Product / Process Change Notification (PCN)

PCN Number: PCN_WCAP-CSRF_20240621

Affected Series: WCAP-CSRF

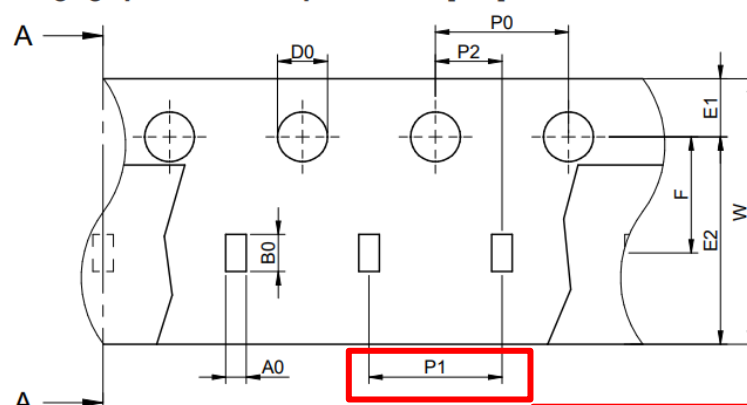
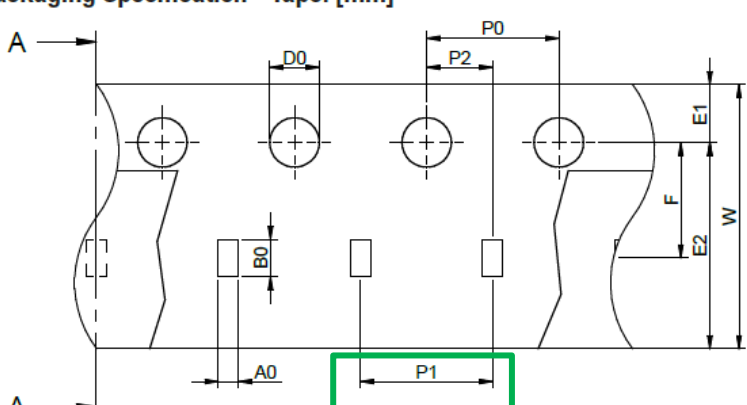
Because of a database mismatch, Würth Elektronik will update the packaging specification in the datasheets for 14 order codes of WCAP-CSRF series.

Corrected dimensions and tolerances are marked with a red box **before change** and green box **after change**.

Effected Order Codes	885392005001, 885392005002, 885392005003, 885392005004, 885392005005, 885392005006, 885392005007, 885392005008, 885392005009, 885392005010, 885392005011, 885392005012, 885392005013, 885392005014																											
Before Change	Packaging Specification - Tape and Reel: [mm]  packaging is referred to the international standard IEC 60286-3:2013 <table><tr><td></td><td>A0</td><td>B0</td><td>W</td><td>T</td><td>T1</td><td>P0</td><td>P1</td><td>P2</td></tr><tr><td>tolerance</td><td>typ.</td><td>typ.</td><td>+0,3/ -0,1</td><td>ref.</td><td>max.</td><td>±0,1</td><td>±0,1</td><td>±0,05</td></tr><tr><td>value</td><td>0,70</td><td>1,20</td><td>8,00</td><td>0,80</td><td>0,10</td><td>4,00</td><td>4,00</td><td>2,00</td></tr></table>		A0	B0	W	T	T1	P0	P1	P2	tolerance	typ.	typ.	+0,3/ -0,1	ref.	max.	±0,1	±0,1	±0,05	value	0,70	1,20	8,00	0,80	0,10	4,00	4,00	2,00
	A0	B0	W	T	T1	P0	P1	P2

tolerance	typ.	typ.	+0,3/ -0,1	ref.	max.	±0,1	±0,1	±0,05																				
value	0,70	1,20	8,00	0,80	0,10	4,00	4,00	2,00																				
After Change	Packaging Specification - Tape: [mm]  Packaging is referred to the international standard IEC 60286-3:2019 <table><tr><td>Tape Type</td><td>A0 (mm)</td><td>B0 (mm)</td><td>W (mm)</td><td>T (mm)</td><td>T1 (mm)</td><td>P0 (mm)</td><td>P1 (mm)</td><td>P2 (mm)</td></tr><tr><td></td><td>typ.</td><td>typ.</td><td>+0,3/ -0,1</td><td>ref.</td><td>ref.</td><td>±0,1</td><td>±0,05</td><td>±0,05</td></tr><tr><td>1a</td><td>0,40</td><td>0,70</td><td>8,00</td><td>0,55</td><td>0,10</td><td>4,00</td><td>2,00</td><td>2,00</td></tr></table>	Tape Type	A0 (mm)	B0 (mm)	W (mm)	T (mm)	T1 (mm)	P0 (mm)	P1 (mm)	P2 (mm)		typ.	typ.	+0,3/ -0,1	ref.	ref.	±0,1	±0,05	±0,05	1a	0,40	0,70	8,00	0,55	0,10	4,00	2,00	2,00
Tape Type	A0 (mm)	B0 (mm)	W (mm)	T (mm)	T1 (mm)	P0 (mm)	P1 (mm)	P2 (mm)

typ.	typ.	+0,3/ -0,1	ref.	ref.	±0,1	±0,05	±0,05																				
1a	0,40	0,70	8,00	0,55	0,10	4,00	2,00	2,00
